NOTICE OF APPROVAL

Planning Case #: Design Study 25057

Project Description: This approval of Design Study 25057 (Wynar) authorizes a revised project at the southwest corner of Mountain View and 8th APN 010055009000, in the Single-Family Residential (R-1) District, previously approved under Design Study approval 23237 (Wynar) (with associated Building Permit 23478), now revised to feature a redwood deck railing with vertical redwood balusters (formerly a metal wire railing), a deck access door with undivided lite glazing (formerly divided lite), compliant exterior light fixtures, and a 1' privacy lattice panel atop an existing 6' fence along the west property line. The revised project, approved on April 11, 2025, on file with the Carmel-by-the-Sea Community Planning and Building Department, is subject to the standard and special conditions of approval herein.

City of Carmel-by-the-Sea
Community Planning & Building Department
Revisions to Planning Approval

WYNAR RESIDENCE
SWC 8th & MT VIEW
WEST FENCE TOP
EXTENSION
12/6/24 R. ZAPANTA

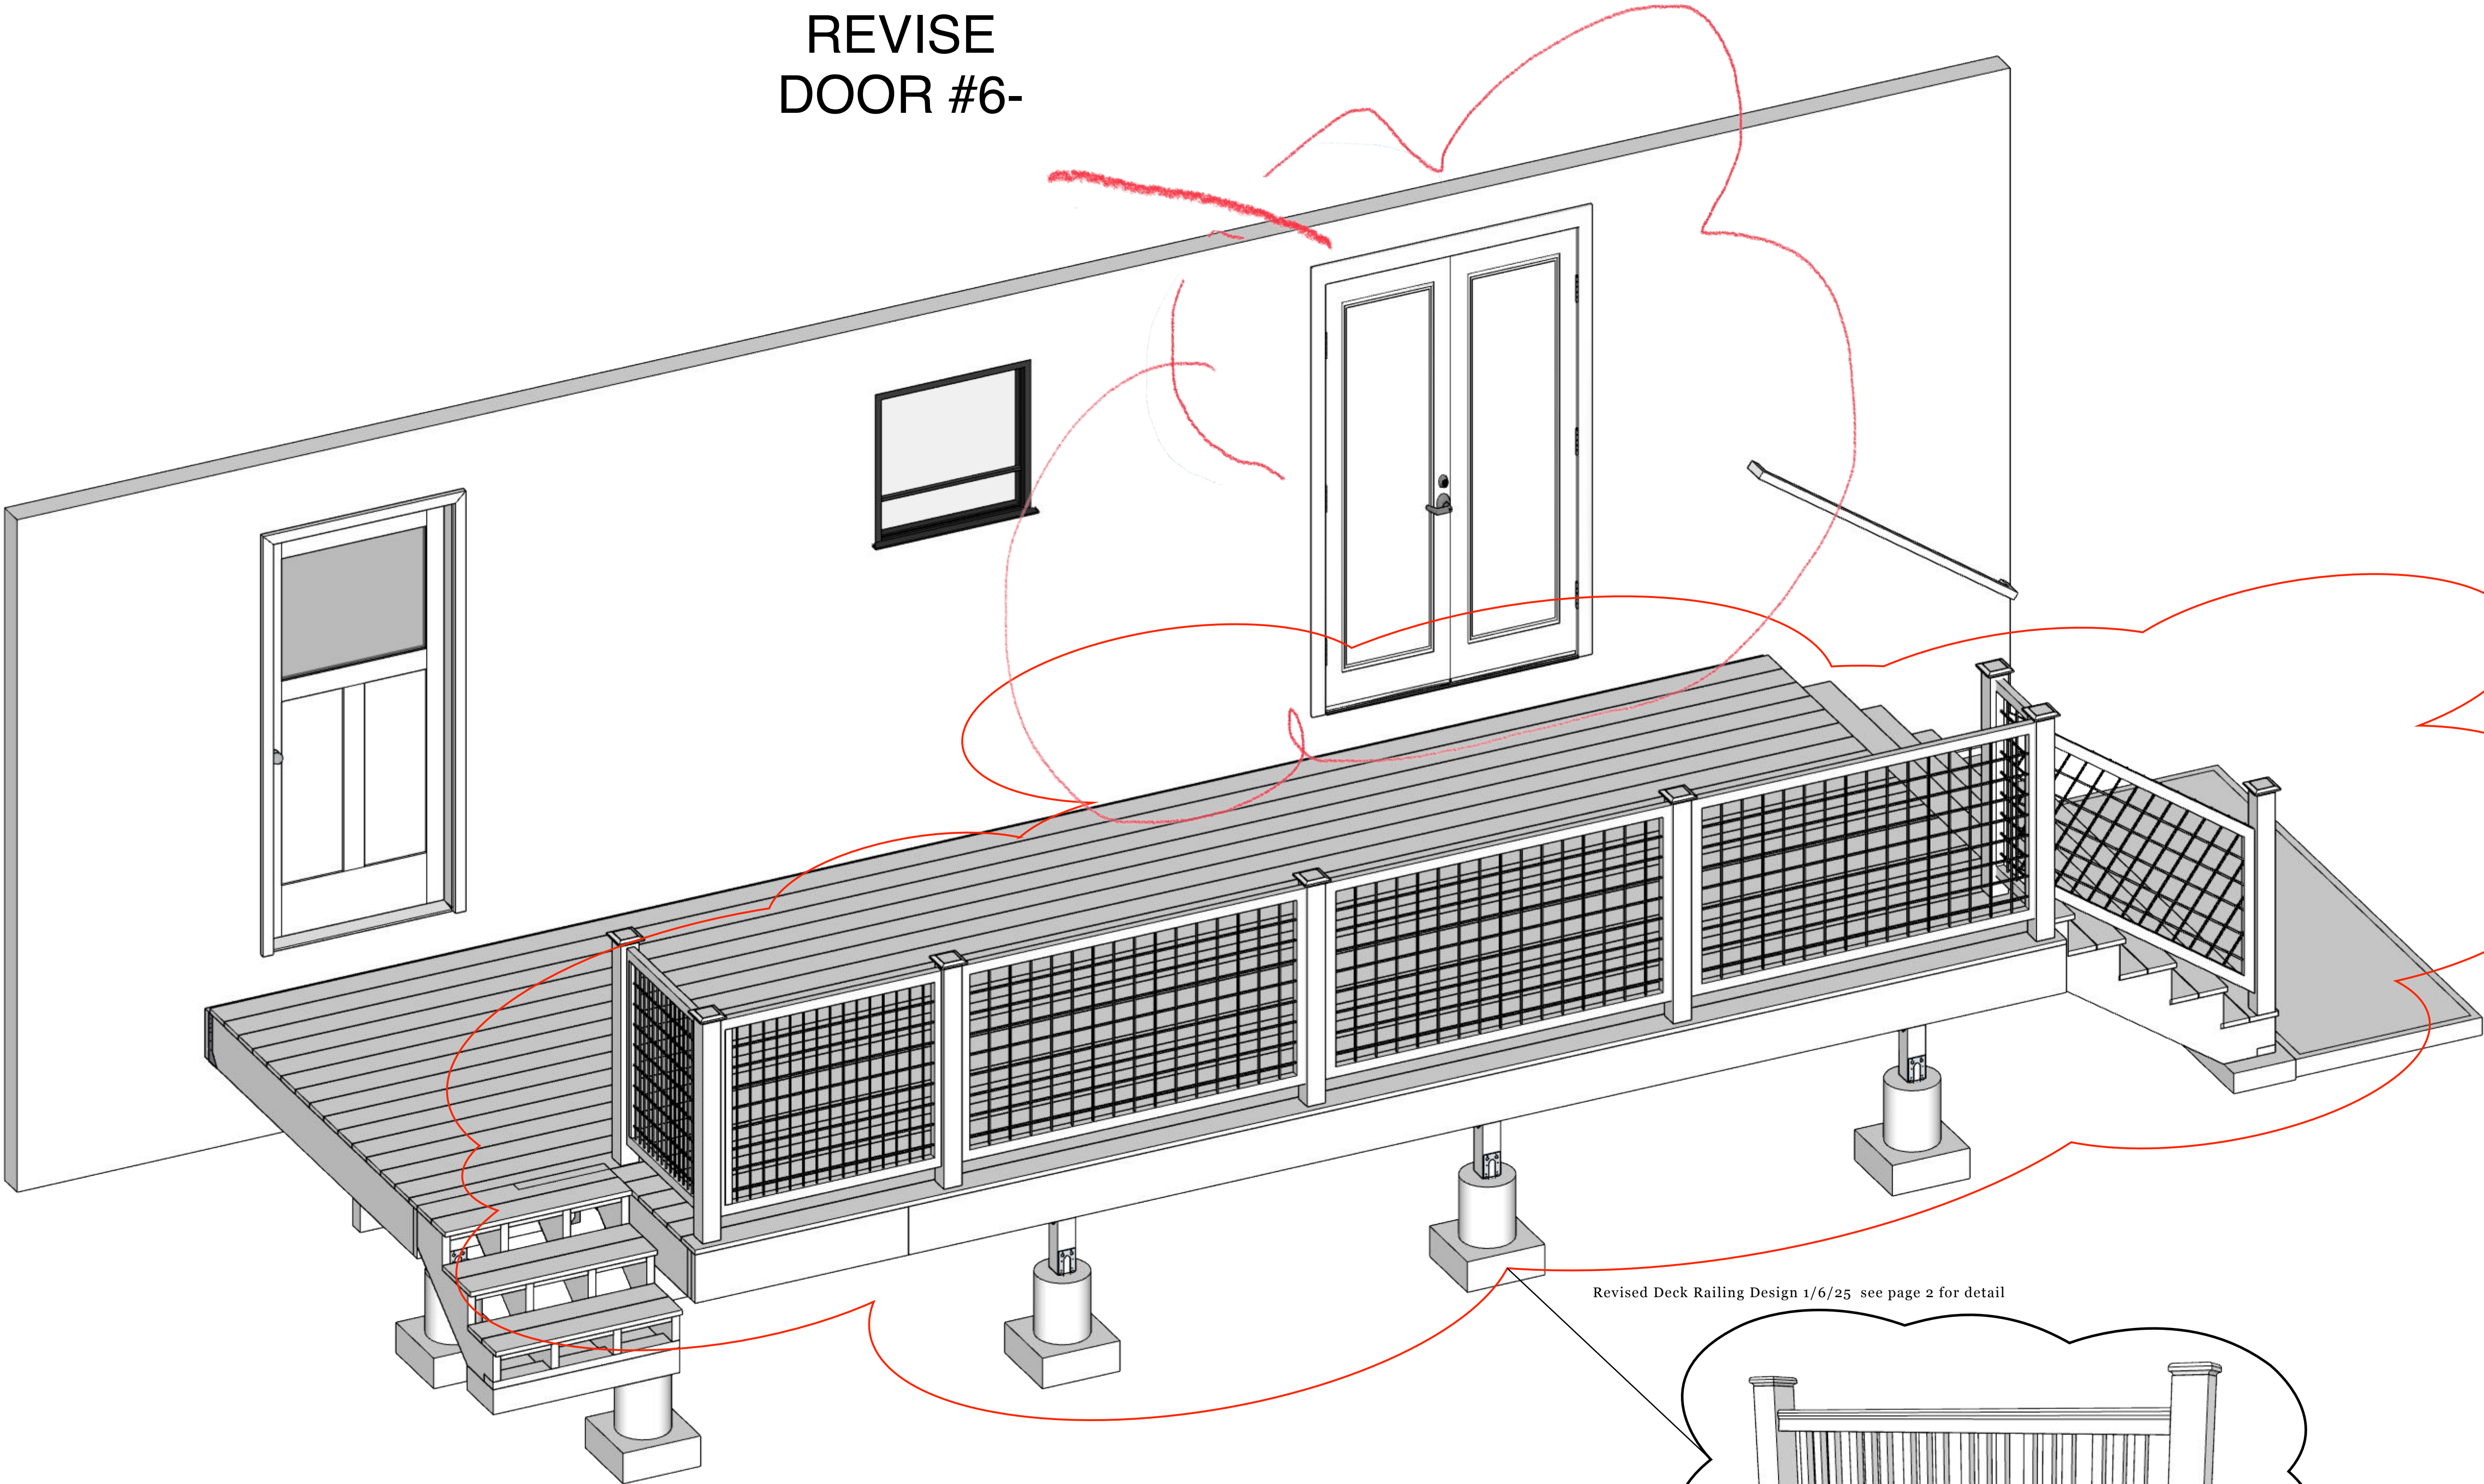
- ☐ Item 5: change divided lite french doors to non-div.
Description of Modification
o Plan sheet(s) modification located: DK pg 1 door #6
- ☐ Item 6: Add 12" lattice fence extension - 38' total
Description of Modification
o Plan sheet(s) modification located: w. fence top extension 12/6/24

Revised Deck Railing Design 1/6/25 see page 2 for detail

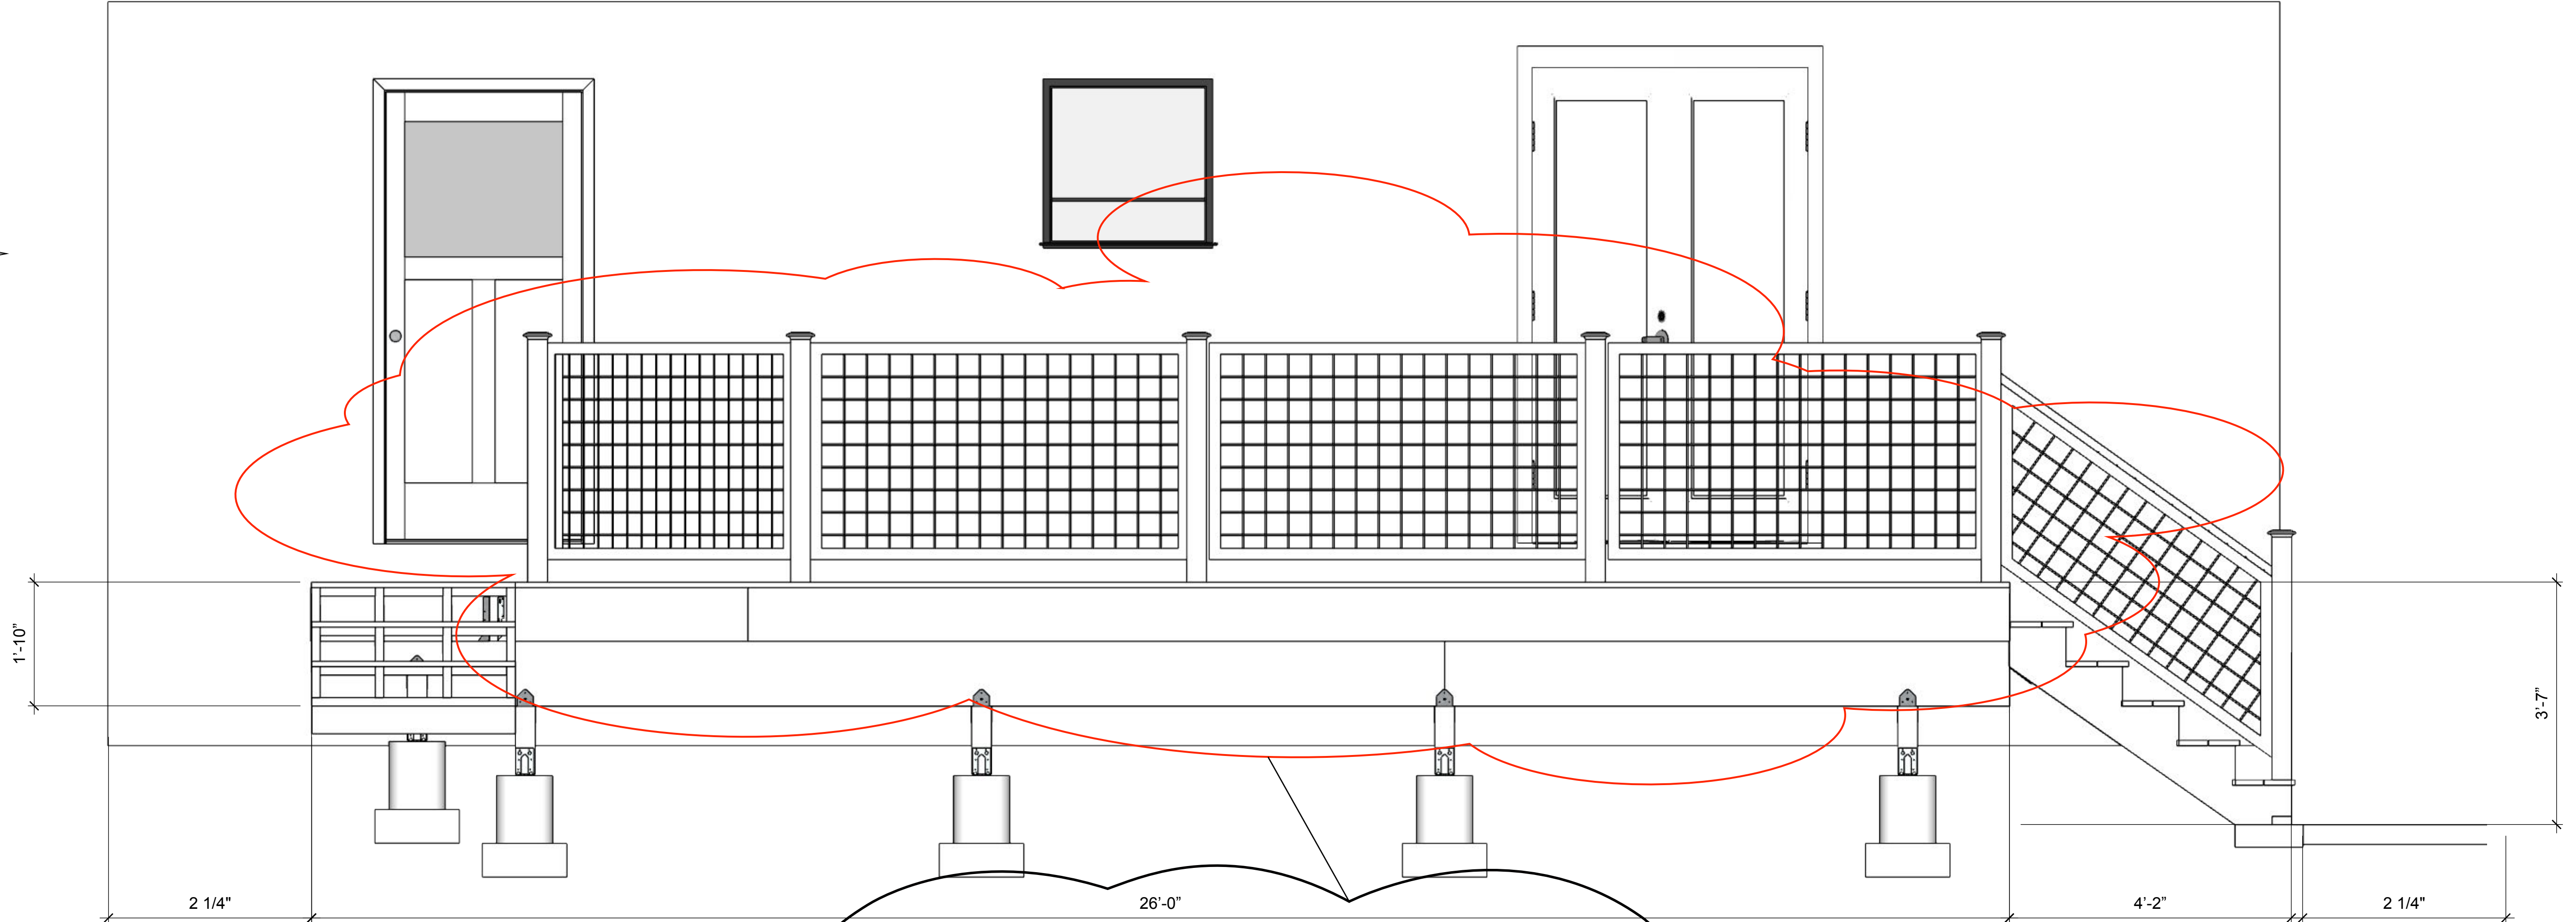
- ☐ Item 7: Replace exist. deck railing w/ redwood
Description of Modification
o Plan sheet(s) modification located: DK pgs 1 + 2
- ☐ Item 8: Replace exterior front lights (2 eq.) w/ 8 1/2"
Description of Modification
o Plan sheet(s) modification located: Minka Kirkham cut sheet PG 4
